Architectural Review Board

June 22, 2021 – 5:30 p.m.

1. PRESENTED BY: Orlando Durr

SUBJECT: Request for approval of a new driveway and request for tree removal in the City ROW for the property located at 125 Hanrick Street (Cottage Hill).

125 HANBUCK Street Site PLAN

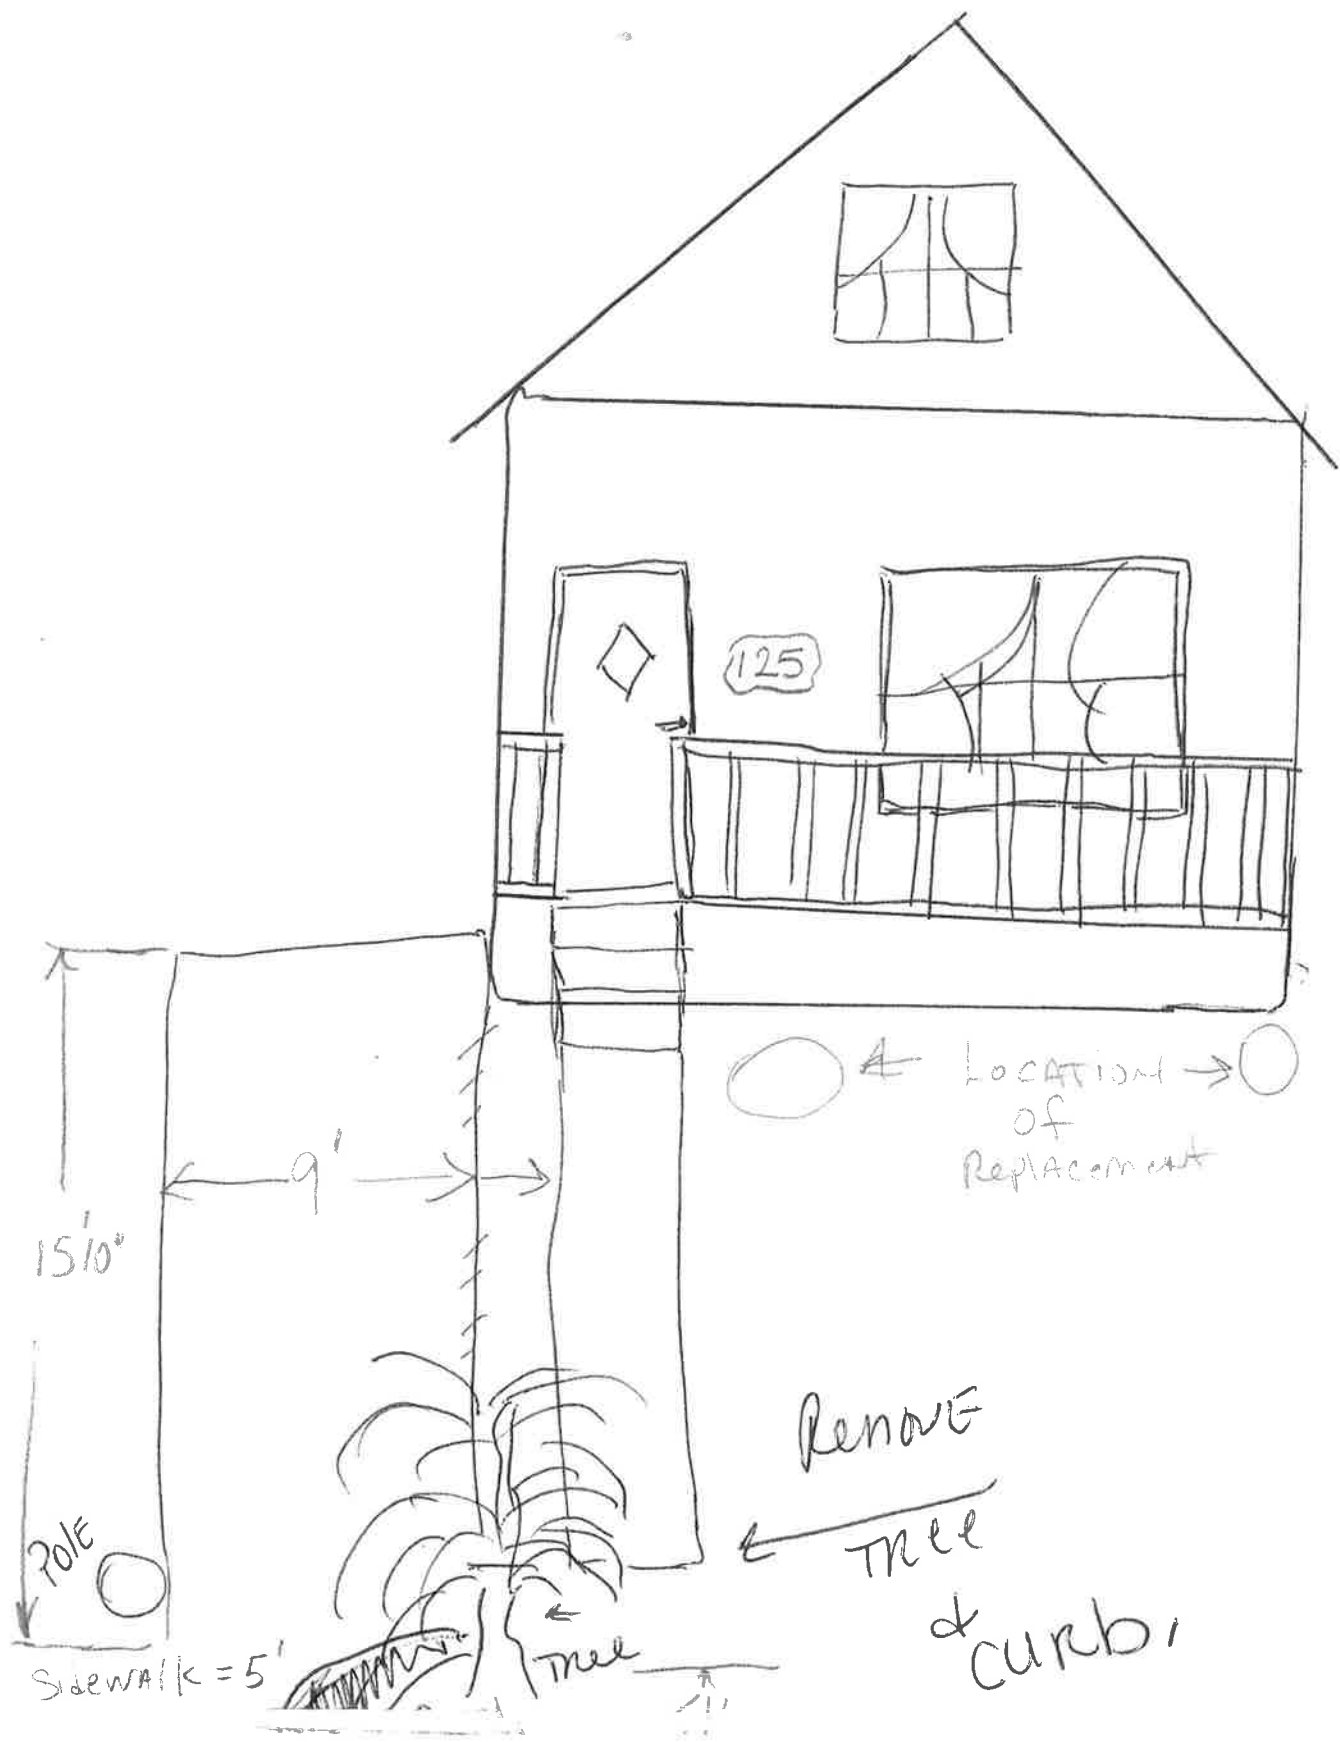
REMARKS: The petitioner is requesting permission to remove a city tree from the ROW that is in the way of a proposed driveway. Petitioner would like to install a new driveway 9' wide and a maximum approximately 50' in length. Based on City maps, it appears from the curb to the back of the sidewalk is approximately 12', the driveway should be at least 20' from the back of the sidewalk to the end of the drive (approximately 32') in order not to block the pedestrian sidewalk. The proposed tree replacements are windmill palms or similar, 6'-8' tall at planting.

- No objection to the tree removal by Urban Forester subject to the payment of a mitigation fee based on the size and species of the tree.
- UF recommends replacing with a canopy tree species, palms are not trees.
